RE: **Item B. \_\_\_ of July 8, 2019 Regular Council Public Hearing Meeting  
Development Application No. 7918-0085-00**

ADDRESS: 14409 – 115 Avenue

PROPOSAL: To allow subdivision into 1 single family lot and 9 single family small lots.

- Summary of Tree Survey and Tree Preservation (revised July 3, 2019).

**T1 - TREE PRESERVATION  
 AND REMOVAL PLAN**

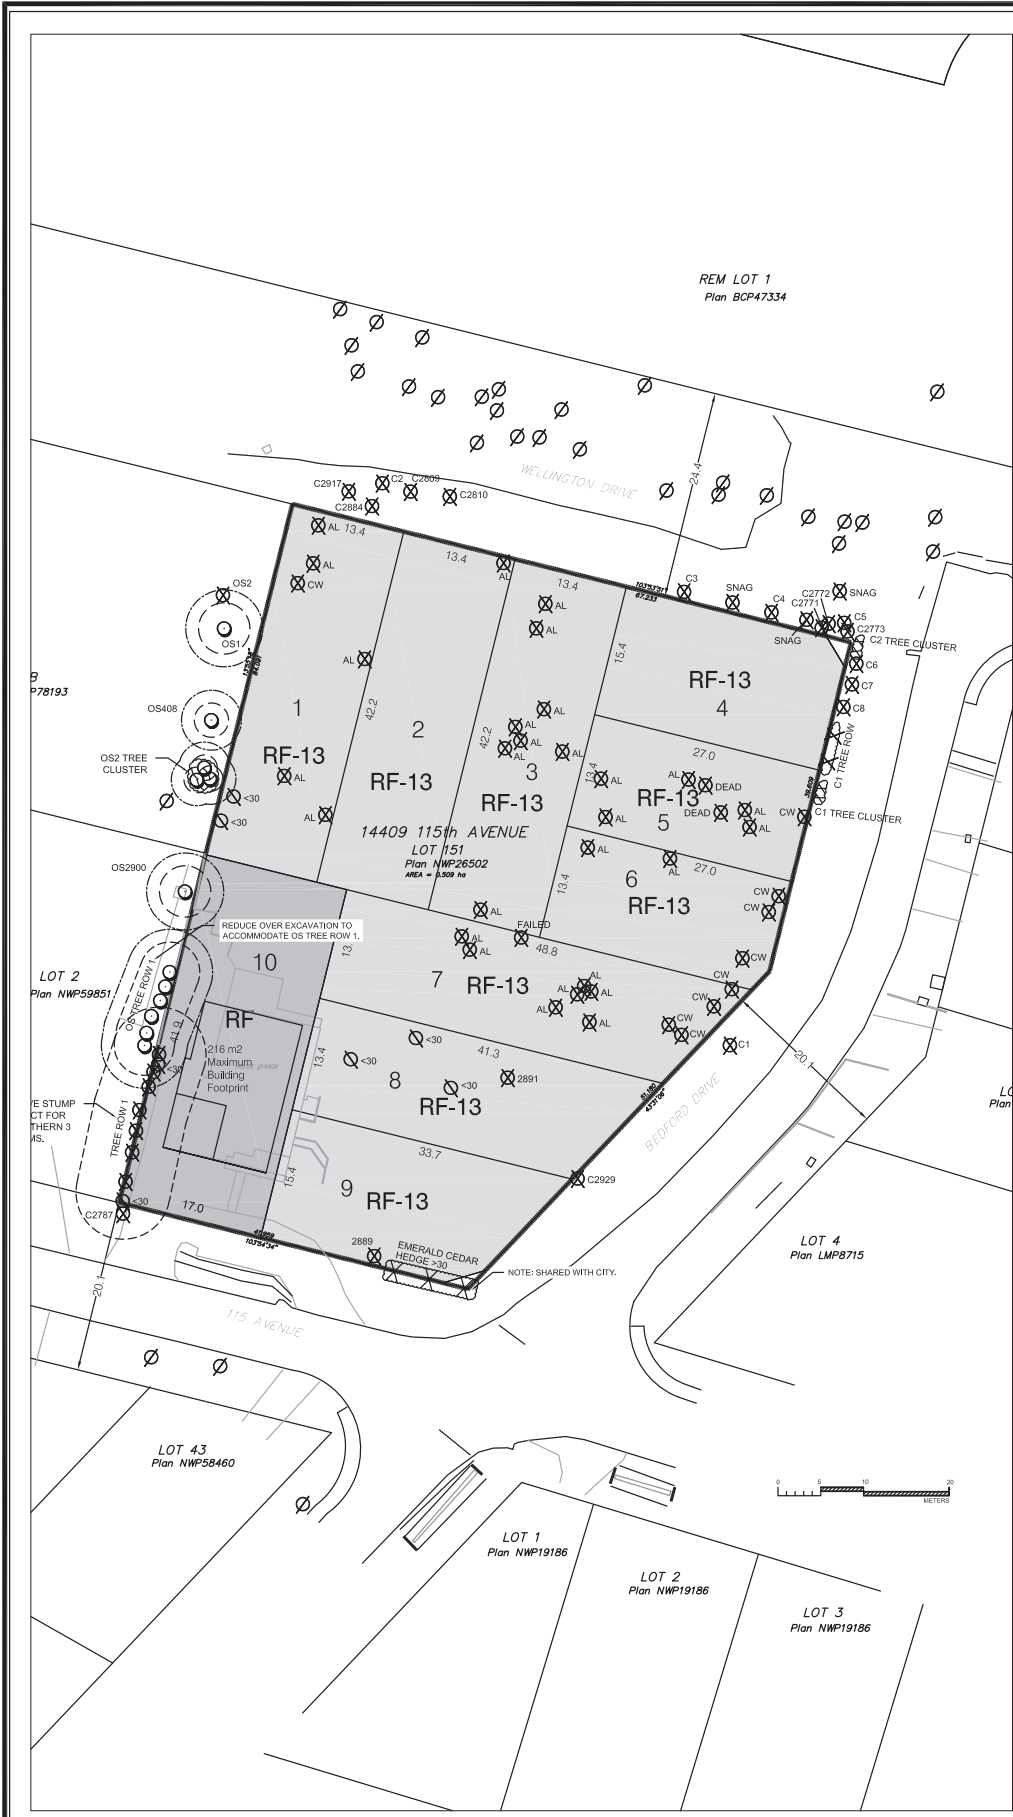
- 1) The project Arborist has confirmed that off-site Tree Row 1, containing six (6) By-law sized trees adjacent to the west side lot line of proposed Lot 10, can be retained. In addition, the stumps of the three (3) northern-most trees in Tree Row 1 will be retained to limit disturbance to the adjacent retained trees (see Summary of Tree Survey and Tree Preservation).
- 2) As the six (6) By-law sized trees identified as off-site Tree Row 1 are proposed to be retained, no additional replacement trees or cash-in-lieu payment to the Green City Fund for off-site tree removal is required.

- 3) The number of replacement trees has been increased from 21 to 26, resulting in an increase from 2 to 3 replacement trees on proposed Lots 1, 2, 3, 7 and 8, which are considered oversized RF-13-zone lots. The deficit of 60 replacement trees will require a cash-in-lieu payment of \$24,000, representing \$400 per tree, to the Green City Fund, in accordance with the City's Tree Protection By-law.
